Re: On-Going Services  
Riverwood Ranch Section 3 Final Plat and Construction Plans – 1<sup>st</sup> Submittal Review  
Angleton, Texas  
HDR Job No. 10361761

HDR Engineering, Inc. (HDR) has reviewed the construction plans and final plat for the above referenced subdivision and offers the following comments:

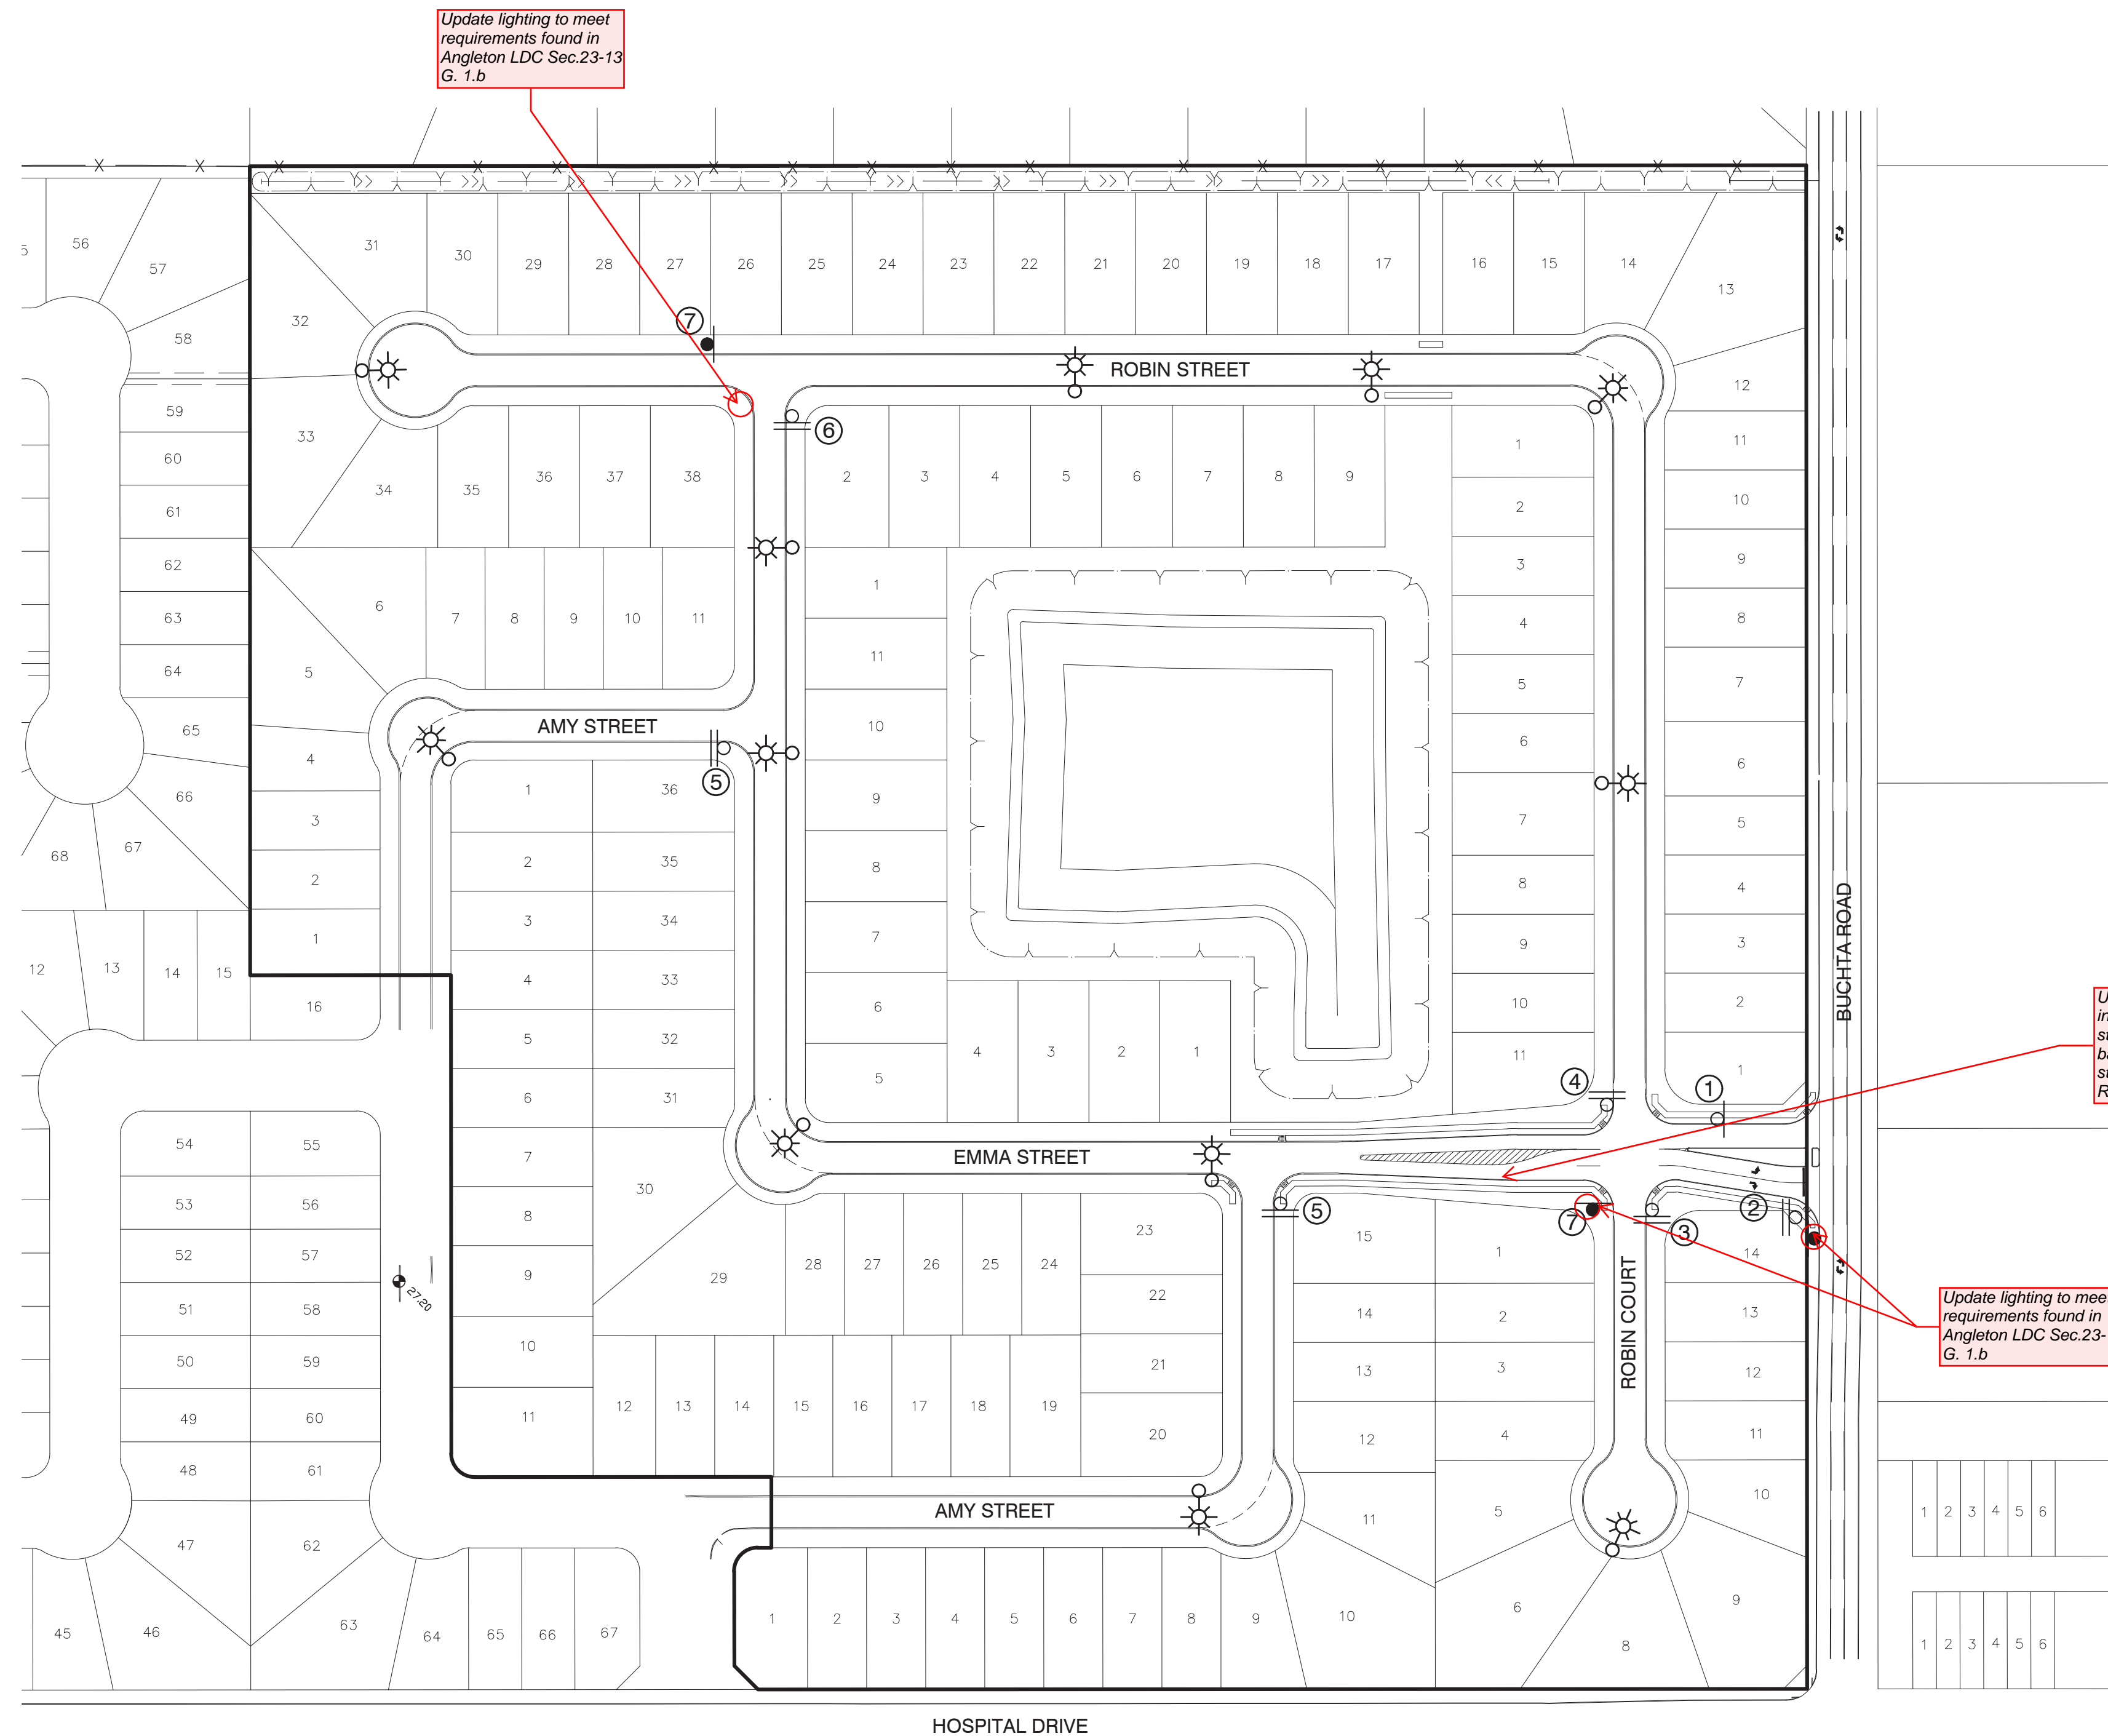
1. Update lighting to meet requirements found in Angleton LDC Sec.23-13 G. 1.b. See sheet for locations.
2. Update plan sheet to include all proposed striping including stop bar locations and striping on Buchta Road.

Update lighting to meet requirements found in Angleton LDC Sec.23-13 G. 1.b

Update plansheet to include all proposed striping including stop bar locations and striping on Buchta Road
